APPLICATION NO.	FILING DATE	FIRST NAMED INVENTOR	ATTORNEY DOCKET NO.	CONFIRMATION NO.
10/562,628	12/22/2005	Wolfgang Arno Winkler	870-003-200	3737
WARE FRESSOLA VAN DER SLUYS & ADOLPHSON, LLP BRADFORD GREEN, BUILDING 5			EXAMINER	
			KASTURE, DNYANESH G	
	755 MAIN STREET, P O BOX 224 MONROE, CT 06468		ART UNIT	PAPER NUMBER
			3746	
			MAIL DATE	DELIVERY MODE
			09/12/2008	PAPER

Application No.	Applicant(s)			
	10/562,628	WINKLER ET AL.			
Office Action Summary	Examiner	Art Unit			
	DNYANESH KASTURE	3746			
The MAILING DATE of this communication app Period for Reply	ears on the cover sheet with the c	orrespondence address			
A SHORTENED STATUTORY PERIOD FOR REPLY WHICHEVER IS LONGER, FROM THE MAILING DA - Extensions of time may be available under the provisions of 37 CFR 1.13 after SIX (6) MONTHS from the mailing date of this communication. - If NO period for reply is specified above, the maximum statutory period w - Failure to reply within the set or extended period for reply will, by statute, Any reply received by the Office later than three months after the mailing earned patent term adjustment. See 37 CFR 1.704(b).	ATE OF THIS COMMUNICATION 36(a). In no event, however, may a re

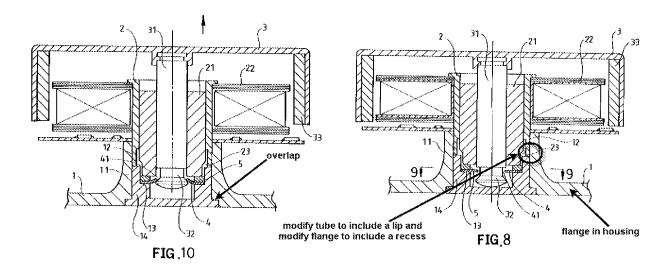
- 3. Claims 1-45 are rejected under 35 U.S.C. 112, second paragraph, as being indefinite for failing to particularly point out and distinctly claim the subject matter which applicant regards as the invention.
- 4. In Re claim 1, .. "which external rotor is equipped with a rotor shaft.." is indefinite because it is not known what the word "which" refers to. The following change is suggested: "..the external rotor is equipped with a rotor shaft..".
- 5. In Re claim 45, the dependency of this claim is based also on claim 45 which is indefinite, for analysis it is assumed that the dependency was on claim 44.

Figure 1 of Ootsuka et al

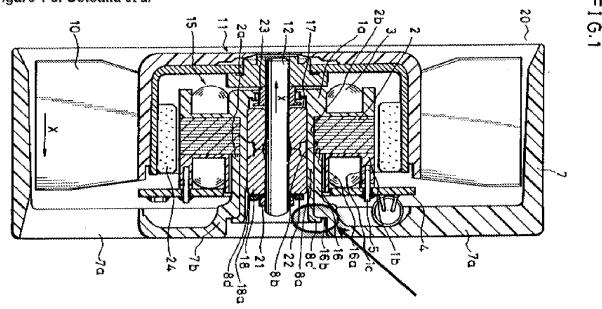
- 23. In Re claim 4, Horng, Fujinaka and Joachimi et al as applied to claim 2 disclose all the claimed limitations except for the bearing tube being held between the closure arrangement and a portion of the flange.

- 24. Nevertheless, with reference to Figure 1 depicted above, Ootsuka et al discloses a lip at the end (8c') of the bearing holding part that is welded to a recess in part (16).

- 25. It would have been obvious to a person having ordinary skill in the art at the time of the invention to modify the end of the bearing tube of Horng so it has a lip as taught by Ootsuka et al, and to form a corresponding recess as taught by Ootsuka et al in the flange section of the housing of Horng resulting in the bearing tube being held between the flange and the closure element by abutting of the closure element, for the purpose of increasing the engaging strength between the axle tube and base as stated in Column 3, Lines 46-50 of Horng et al: "the lower portion of the outer periphery of the axle tube 11 is securely engaged with the inner periphery of the flange 102, with the

- 26. In Re claim 5, Ootsuka et al discloses a lip at the end (8c') of the bearing holding part is welded to a recess in part (16), a weld can be made liquid tight. Also Horng et al states that rotation of the axle tube relative to base is prevented suggesting a press fit (Column 3, Lines 51-53 of Horng et al).

- 27. In Re claims 7, 8, 9 Horng modified Ootsuka et al disclose the radial projection (implemented as a flange) is provided at the end of the tube positively engaged between the closure arrangement and flange as suggested by the combination of the elliptically annotated inserts in the figures above.

- 28. In Re claim 17, Ootsuka et al discloses the lip which is an annular ridge and the recess which is the annular groove that are in a latching connection as depicted. The transition point can also be read as the weld discussed in claim 5. The weld in itself could be read as the groove/ridge combination.

- 29. In Re claim 19, Ootsuka et al discloses the portion that protrudes away is the ridge/lip installed in an opening/recess part.
